Gaylord Community Schools
SF 3.2 NEMSCA Transportation Office
Gaylord, Michigan

October 5, 2020

Project No. 284-20B

ADDENDUM NO. 1

SHEET
M1

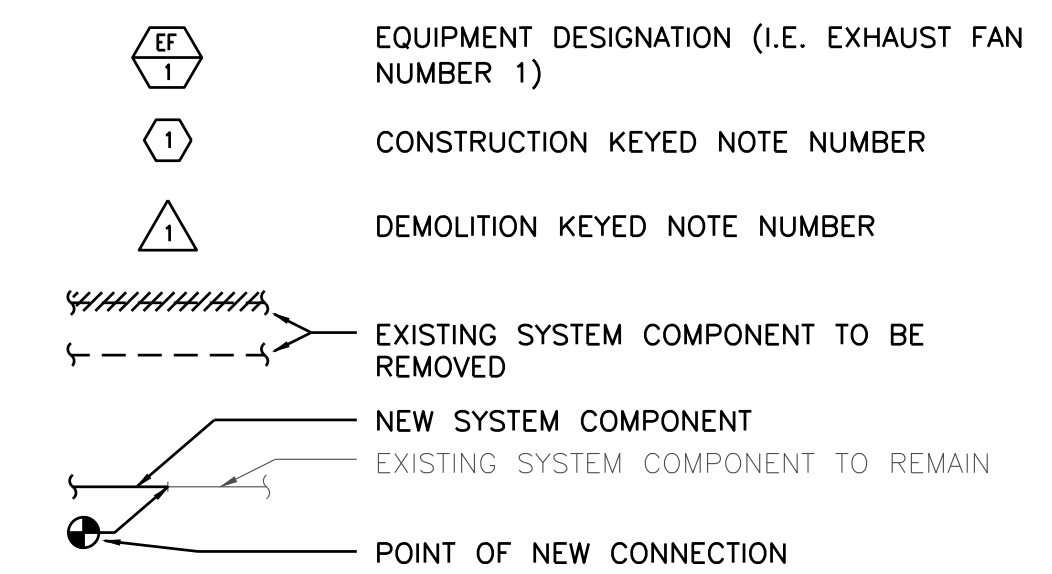
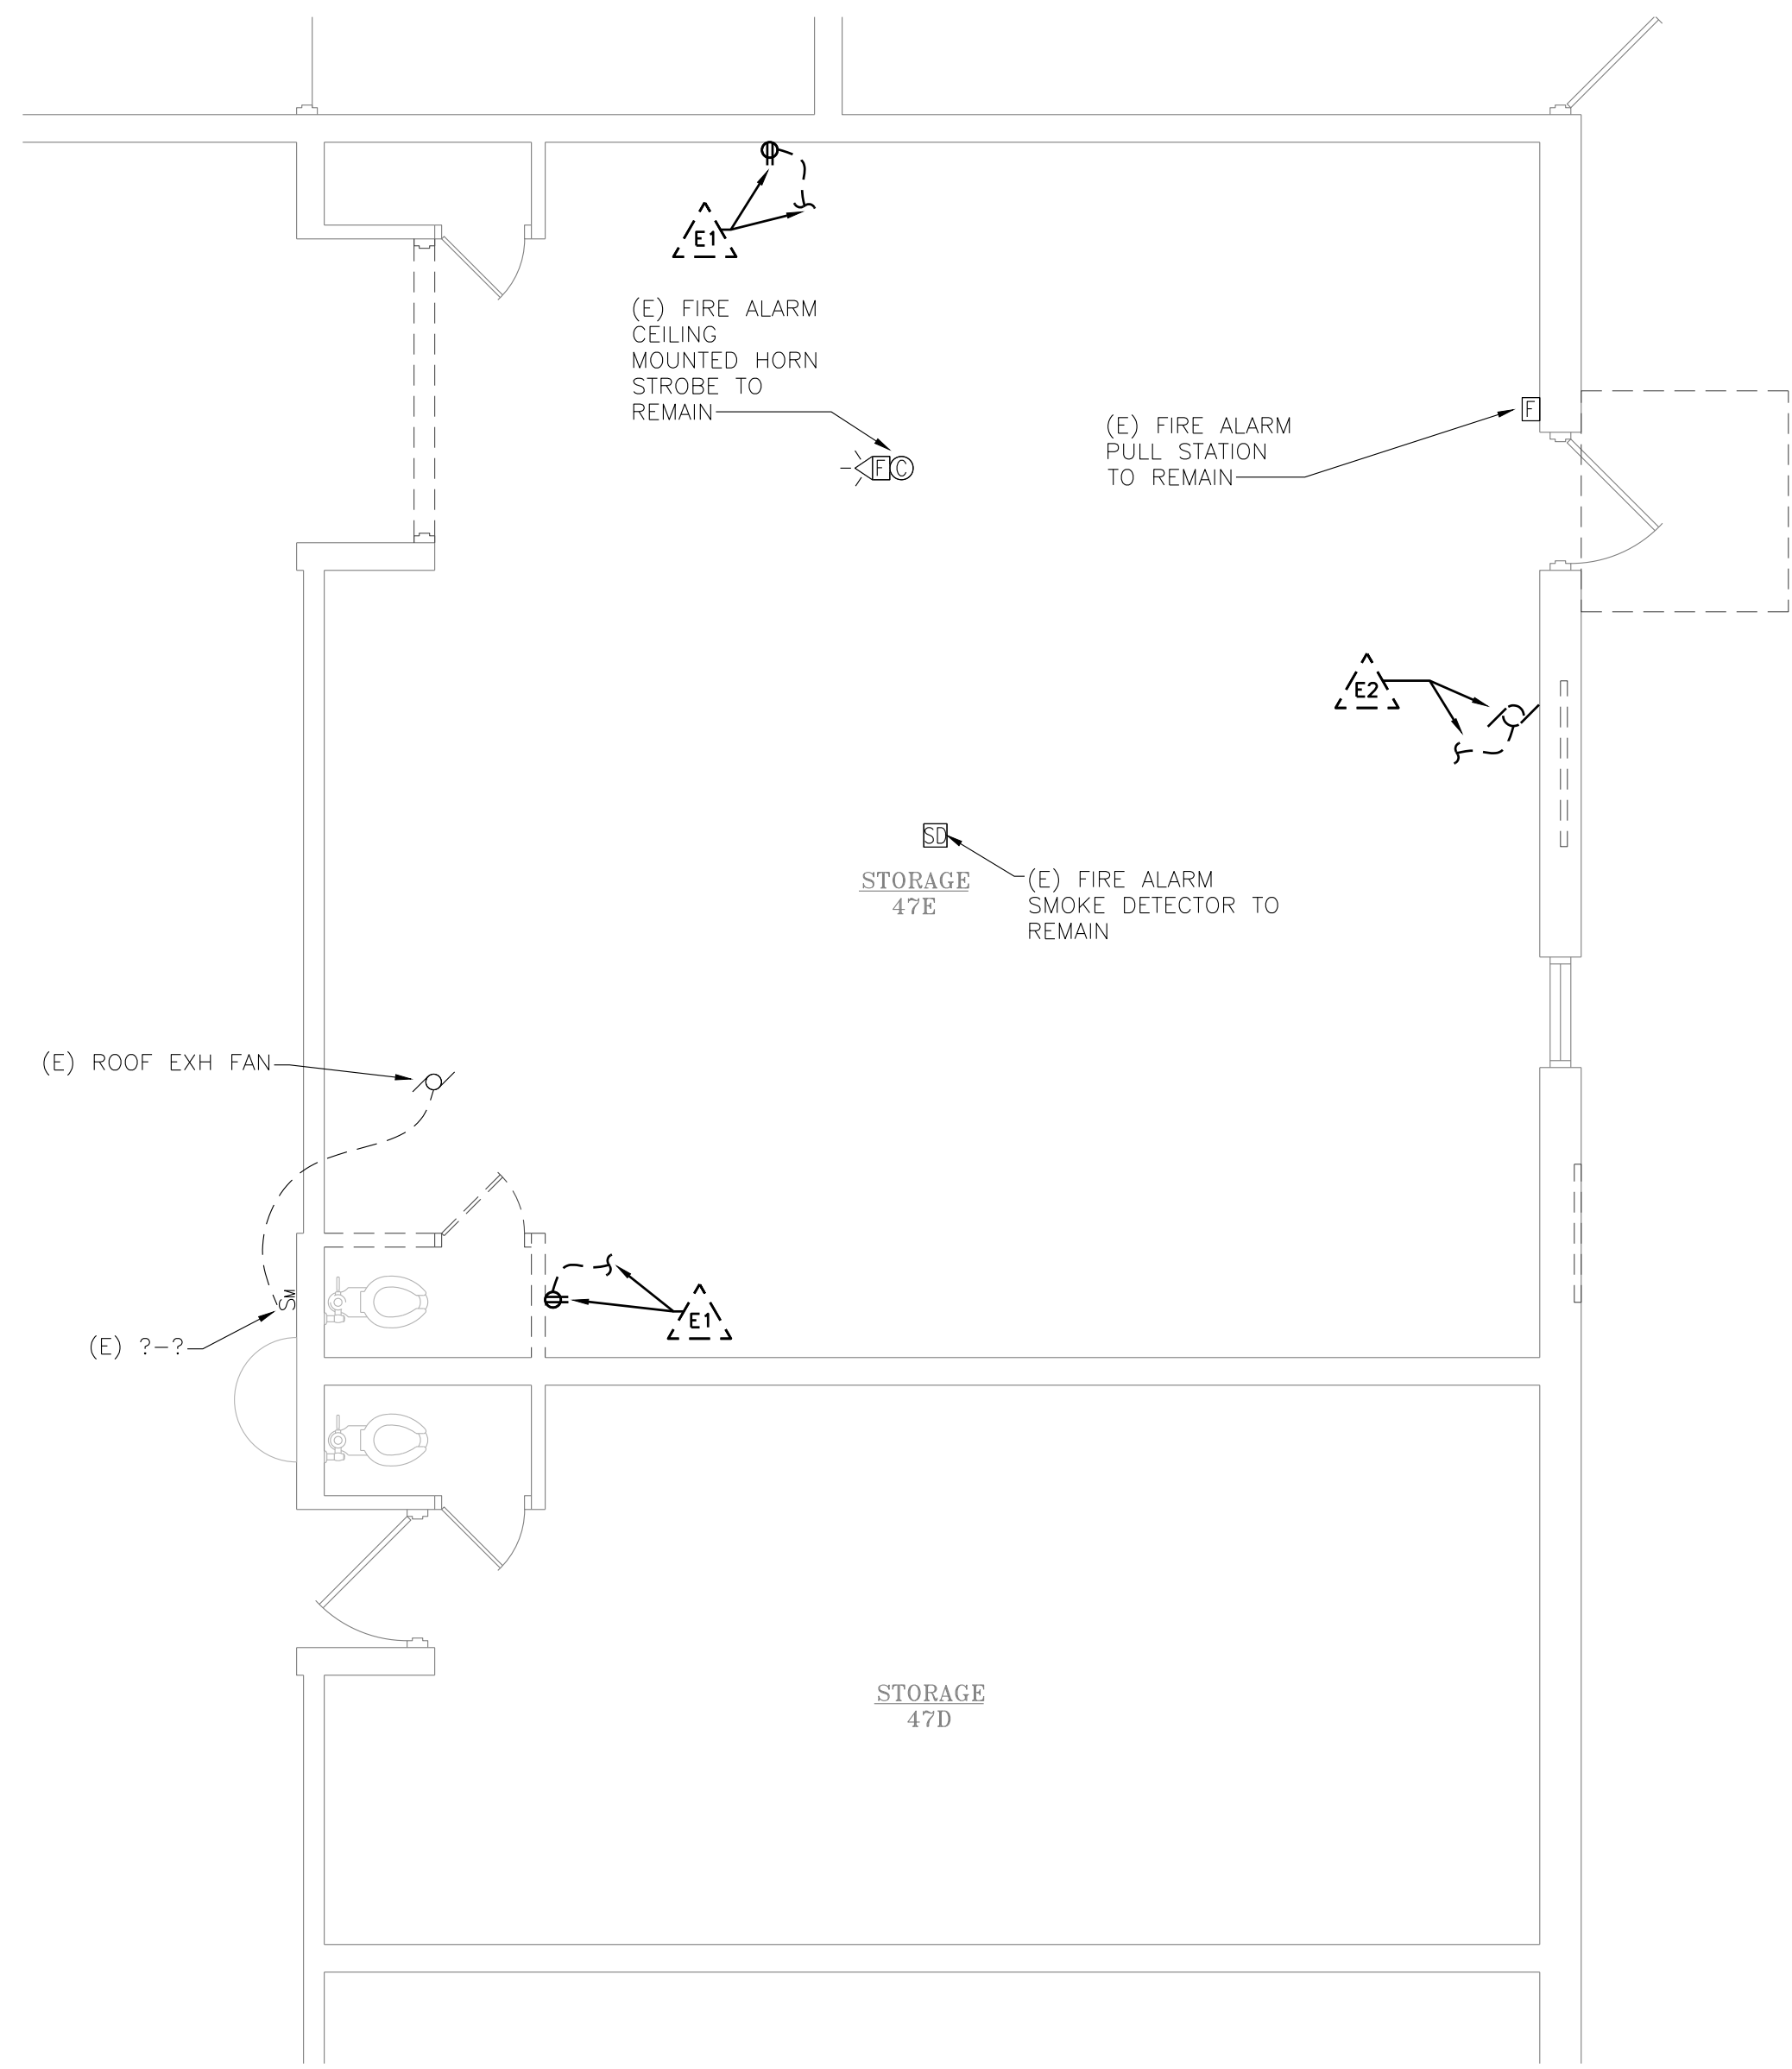
- Item No. 4: Refer to revised drawing sheet A2: Note deletion of Keyed Demolition Tags D11 and Keyed Construction Tags A8 from the respective plans.
- Item No. 5: Refer to revised drawing sheet M1: Note changes in Ductless-Split Air-Source Heat Pump schedule and notes to add Mechanical Support Platform for AHP-TO mounting on roof and also Pipe Portal for refrigerant lines/electrical feeds to/from the AHP-TO and FC-TO.

- NOTES:
- MODEL NUMBERS ARE MITSUBISHI "P-SERIES". FUJITSU AND DAIKEN MAY BE BID AS EQUAL.
 - PROVIDE/INSTALL REFRIGERANT LINES TO/FROM INDOOR FAN COIL TO ROOF MOUNTED CONDENSING UNIT PER MFR REQUIREMENTS. ROUTE REFRIGERANT LINES & POWER/CONTROLS THRU EXISTING ROOF VIA PORTAL PLUS 5-HOLE PIPE PORTAL/ROOF CURB/BOOT SYSTEM. COORDINATE LOCATION & ROOF MOUNTING REQUIREMENTS WITH ROOFING CONTRACTOR.

- MOUNT CONDENSING UNIT ON A MECHANICAL SUPPORT PLATFORM (MIRO #STANCHIONED HD-BG - 38"W x 14"D WITH 24" HIGH LEGS ABOVE ROOF), WITH PROPER CLEARANCES AS REQUIRED FOR AIRFLOW AND MAINTENANCE. COORDINATE LOCATION & ROOF MOUNTING REQUIREMENTS WITH ROOFING CONTRACTOR.

DRAWING TITLE	ELECTRICAL POWER PLANS		
	NEMSCA TRANSPORTATION OFFICE		
PROJECT TITLE	GAYLORD COMMUNITY SCHOOLS - PROJECT SF3.2		
	NEMSCA TRANSPORTATION OFFICE		
PROJECT NO.	284-20B		
	GAYLORD, MICHIGAN		
DATE	9/18/2020		
	10/5/2020		
SHEET	E2

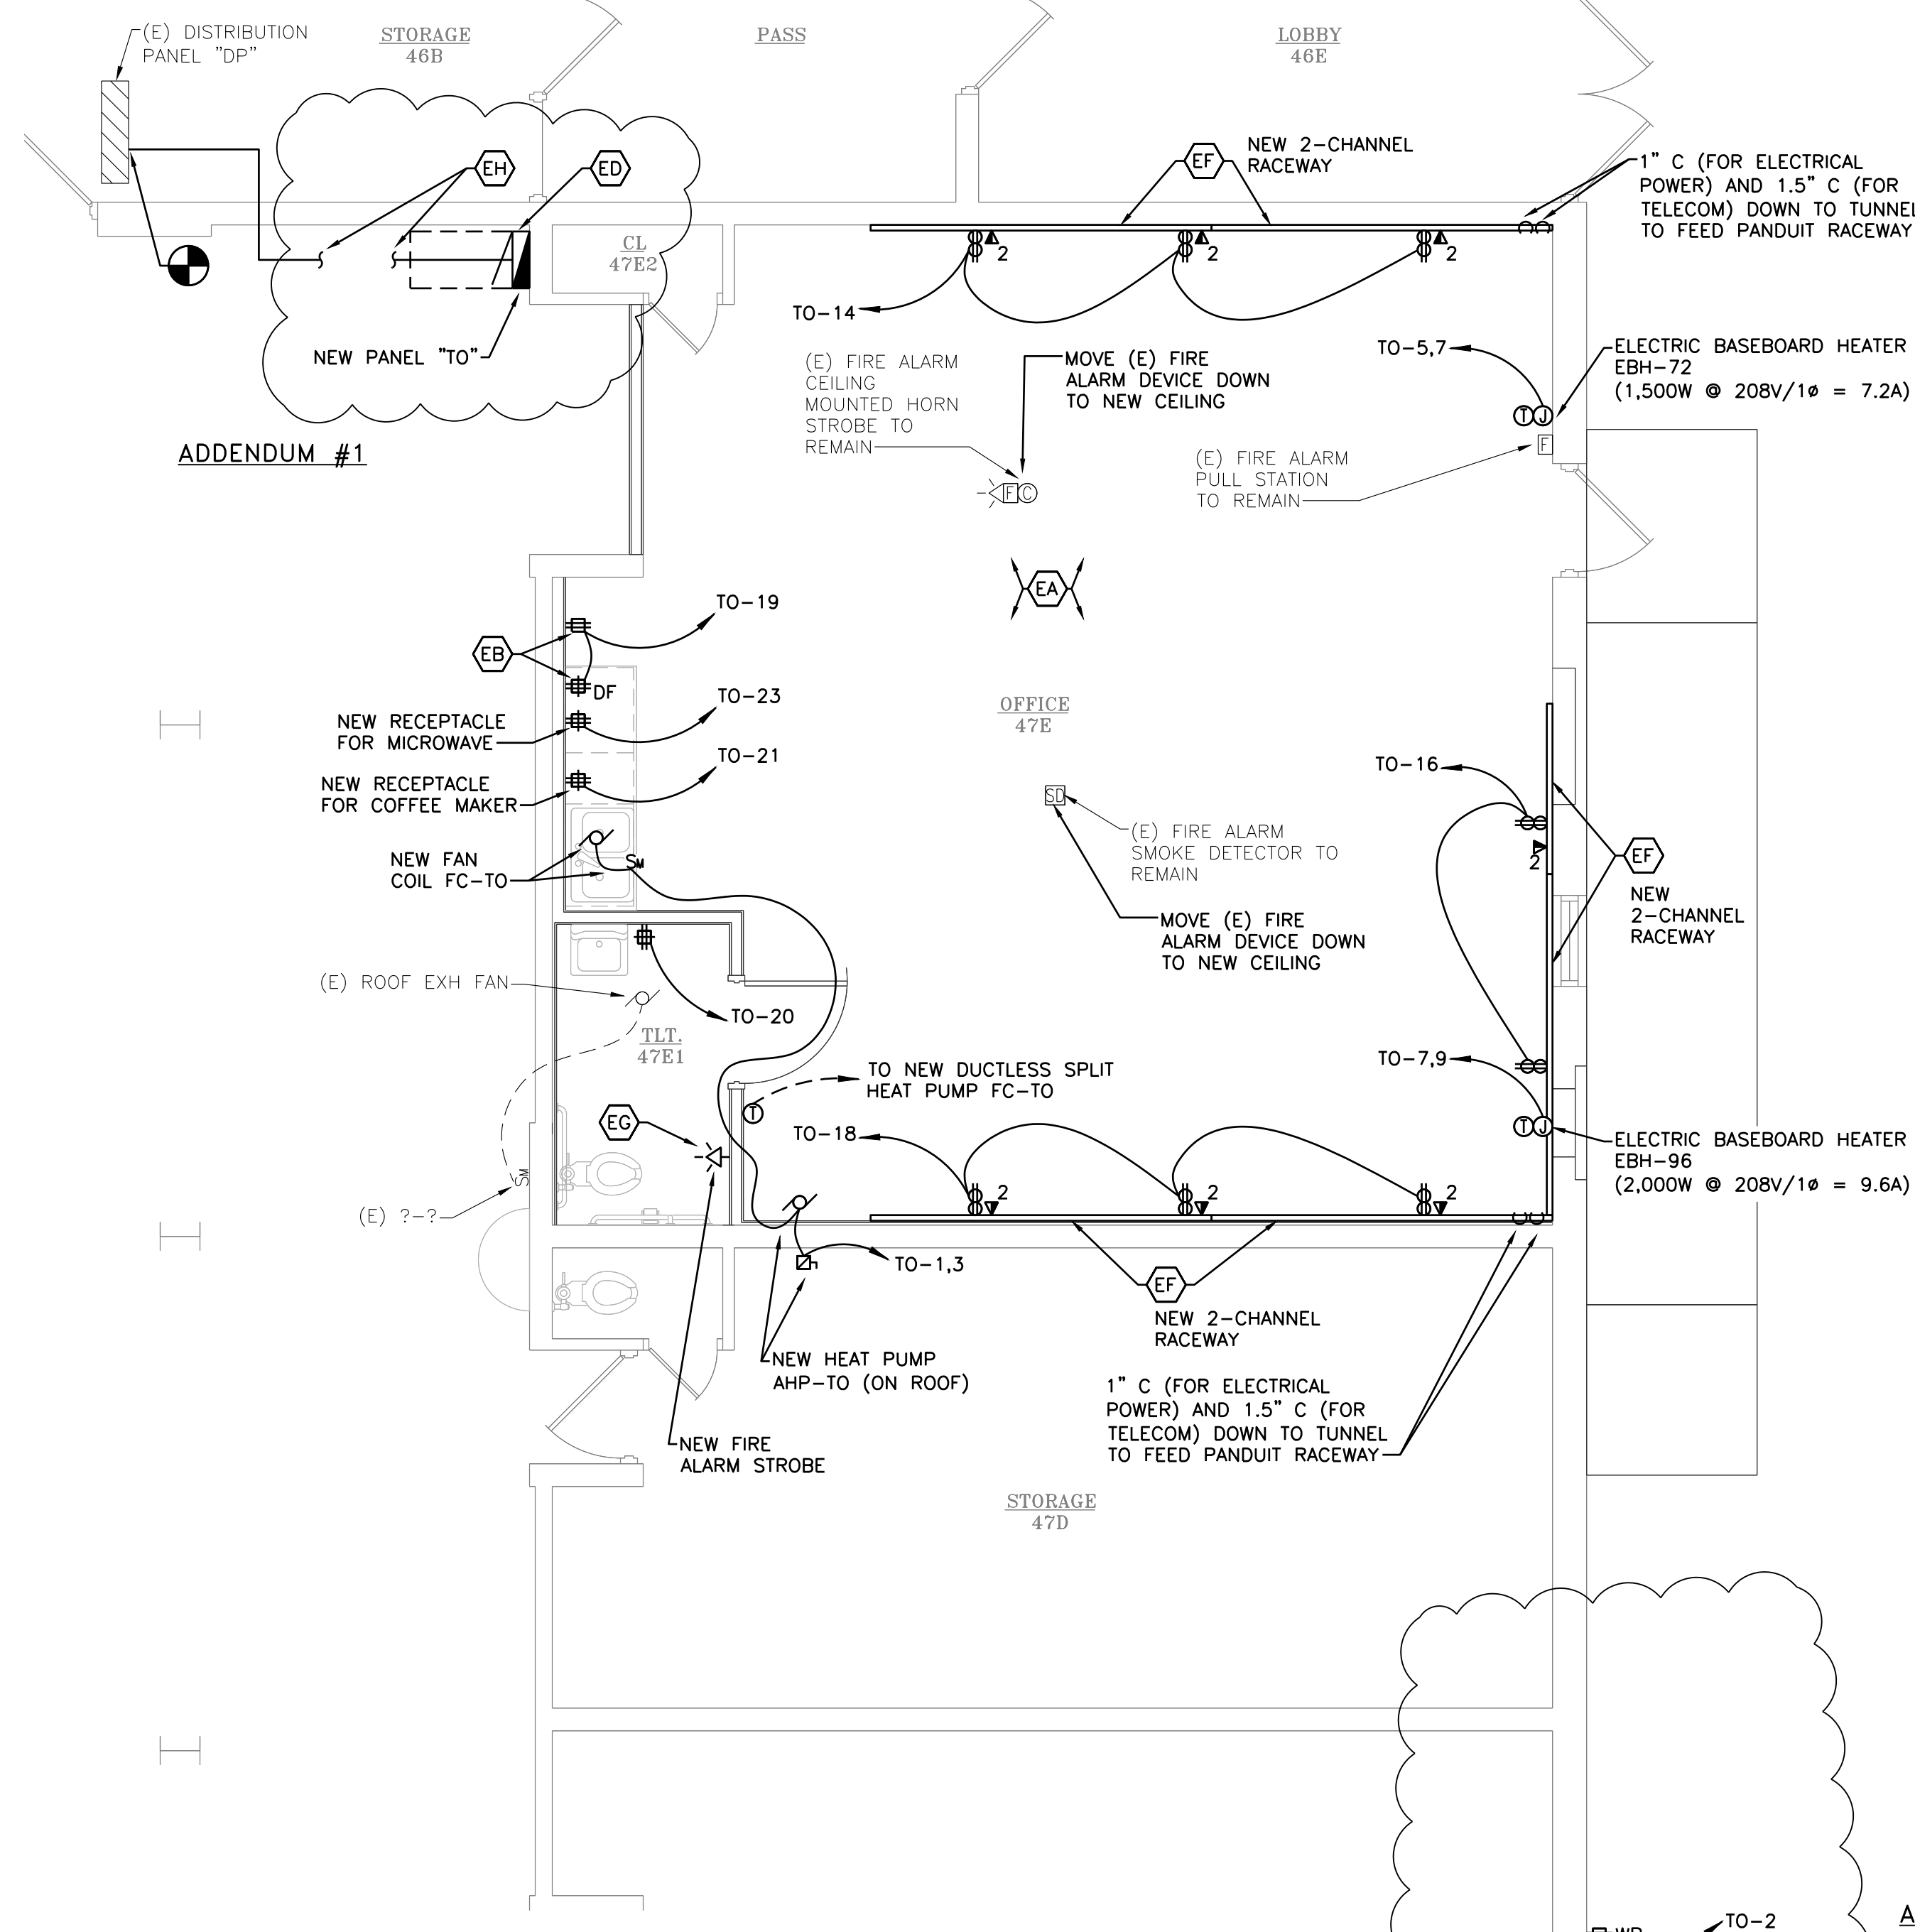
- Item No. 6: Refer to revised Drawing sheet E2: Note change in location for panelboard TO outside of closet 47E2; and change to bus heater receptacles to regular 20A@120V GFCI/WP receptacles.

- COORDINATE AND CONFIRM NEW ELECTRICAL PANEL "TO" LOCATION WITH OWNER PRIOR TO ROUGH-IN.
- PROVIDE FEEDER (4-#3 CU + 1-#8 CU GRD IN 1-1/2" CONDUIT) FOR NEW SUB-PANEL "TO" FROM EXISTING SPARE 100A/3P BKR/SWITCH IN EXISTING DISTRIBUTION PANEL "DP" LOCATED IN STORAGE GARAGE 46B (APPROX. 60 FEET TO THE NORTH OF NEW PANEL "TO". E.C. SHALL FIELD VERIFY & CONFIRM EXISTING CONDITIONS PRIOR TO ROUGH-IN.
